FLORIDA POWER CORPORATION
ST. PETERSBURG, FLORIDA
CRYSTAL RIVER PLANT
UNIT NO. 3 835,000 KW
ELECTRICAL
CONDUIT LAYOUT
REACTOR BUILDING-ELEV. 95'-0" SOUTH

6203 10 E-215-061

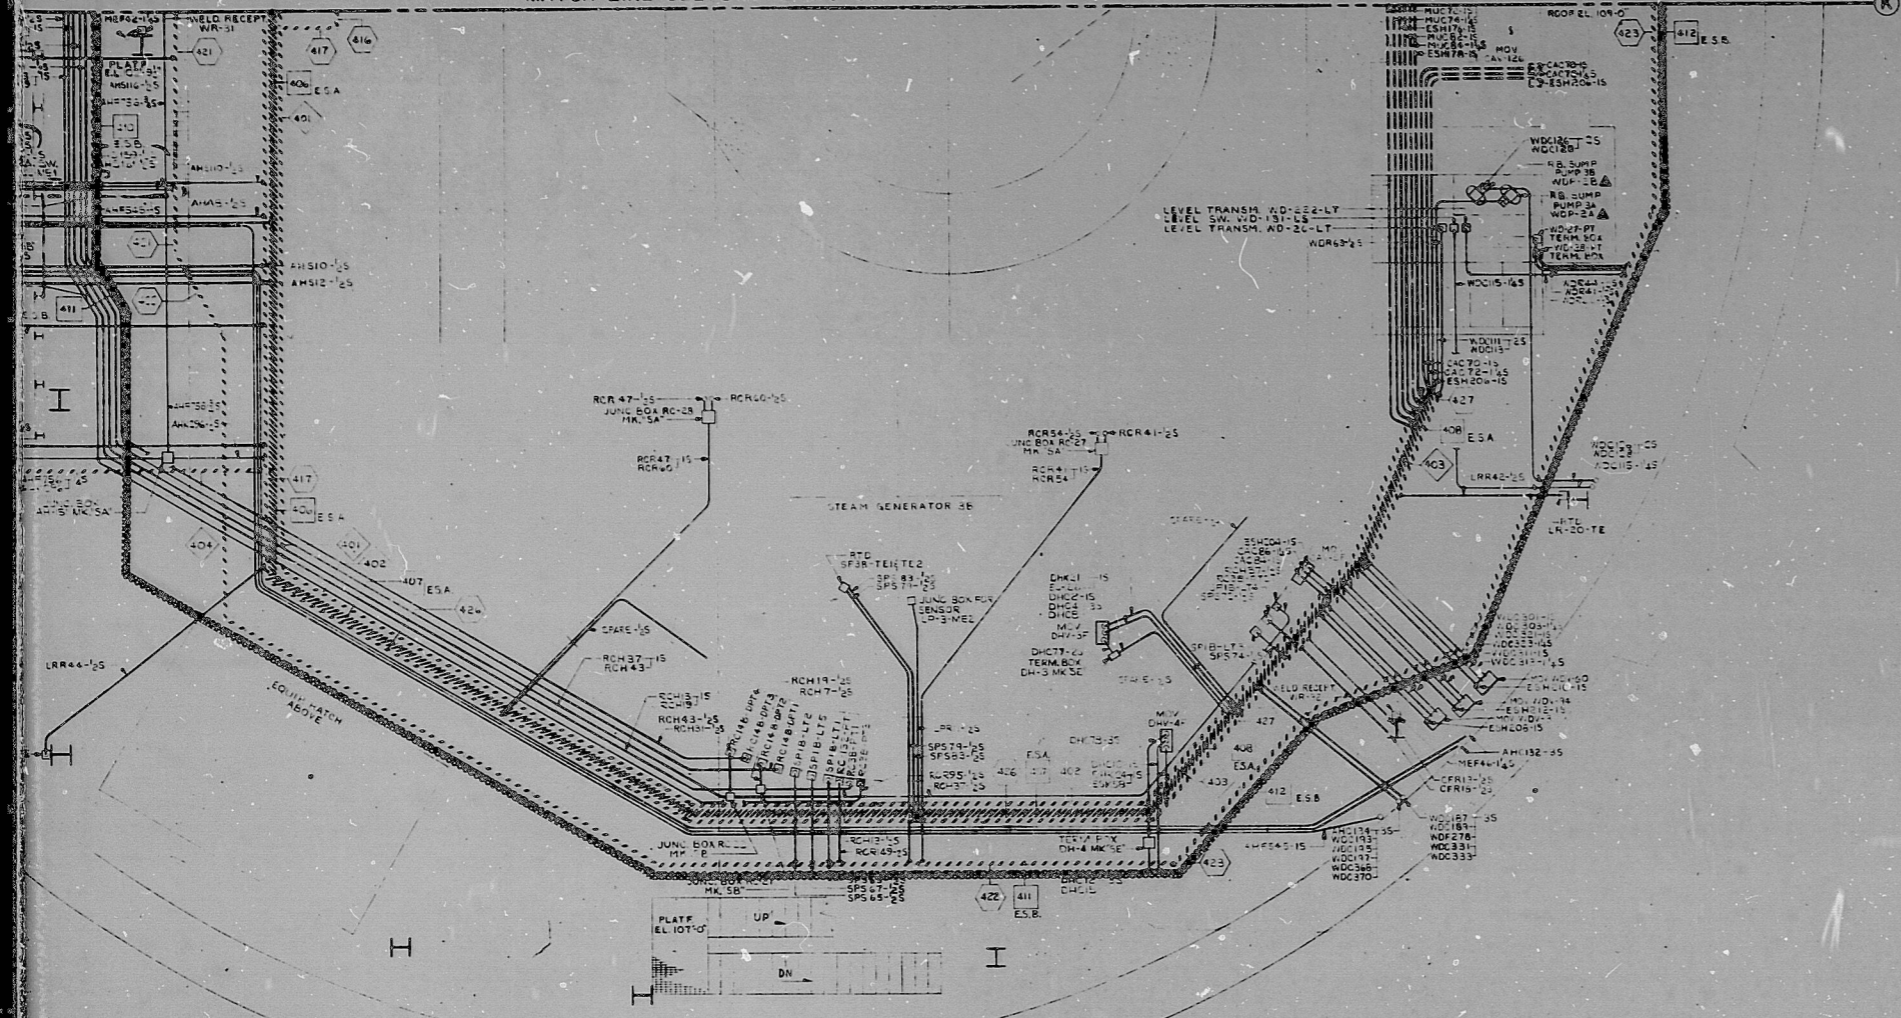
CHANGE IN PROGRESS
DUE TO
M.A.R./R.E.I. 79-5-75

CHANGE IN PROGRESS
DUE TO
M.A.R./R.E.I. 79-1-23

CHANGE IN PROGRESS
DUE TO
M.A.R./R.E.I. 79-10-12
